PLANNING COMMISSION
 Staff report and recommendation
 for
 PC 24 27 PUD 01
 PC 24 28 SUB 01

PC HEARING DATE: December 17, 2024

PREPARED BY: Jacob Foutz, Planning Manager

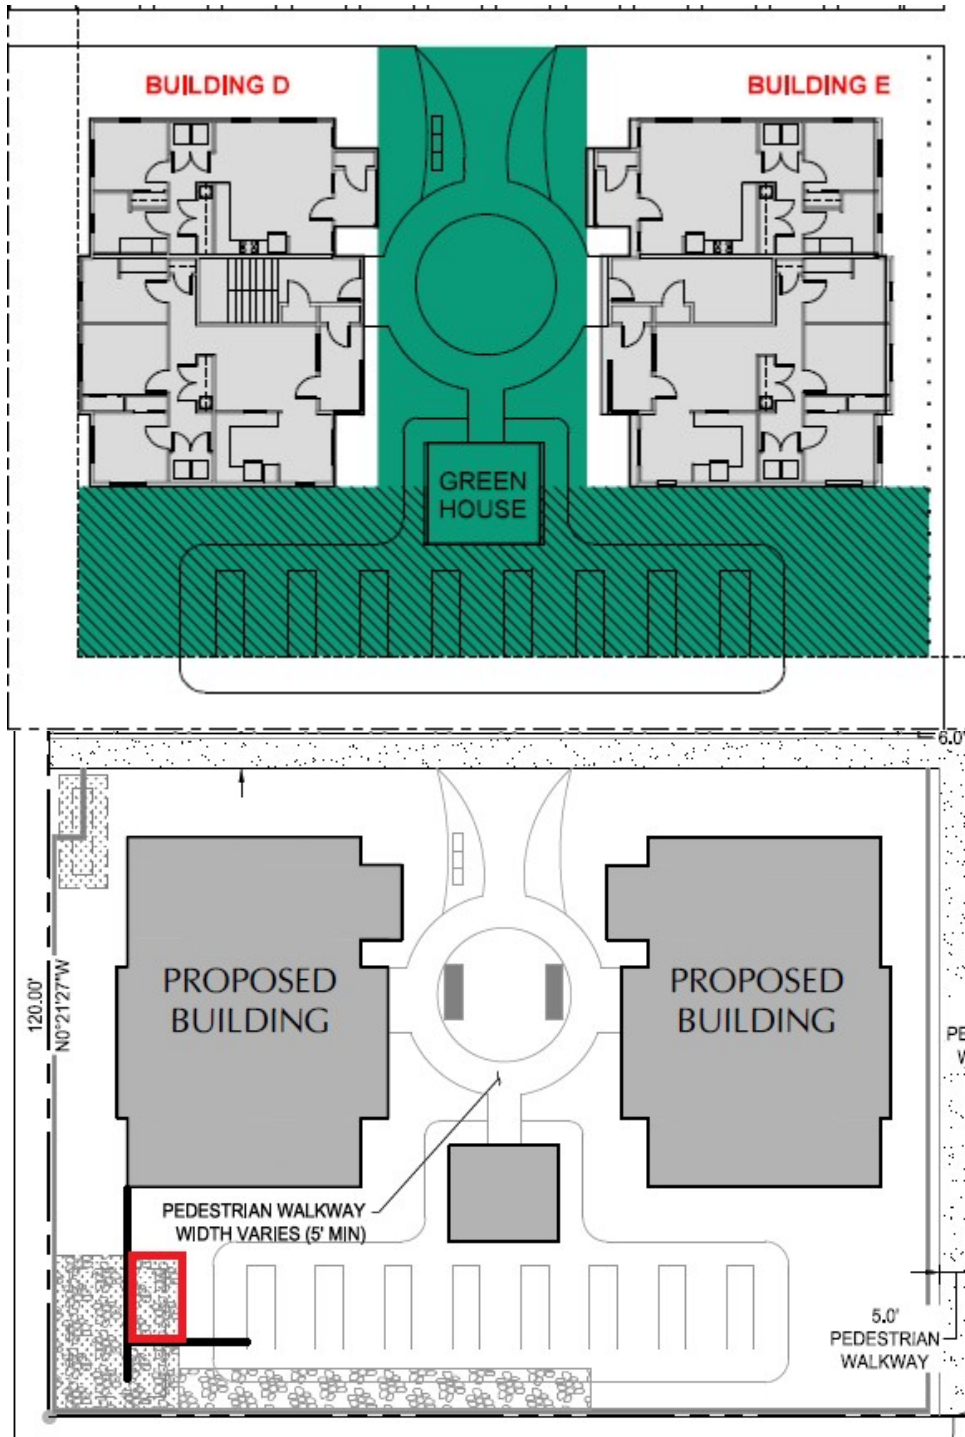
It should be noted that at the corner of the development where 10th Street and Fir Street meet, there is a conflict with the open space/recreation (exhibit K) and stormwater facilities (exhibit N-1). This is illustrated below. [A condition of approval will be added to ensure that open space and stormwater do not overlap.](#) (COA#1)
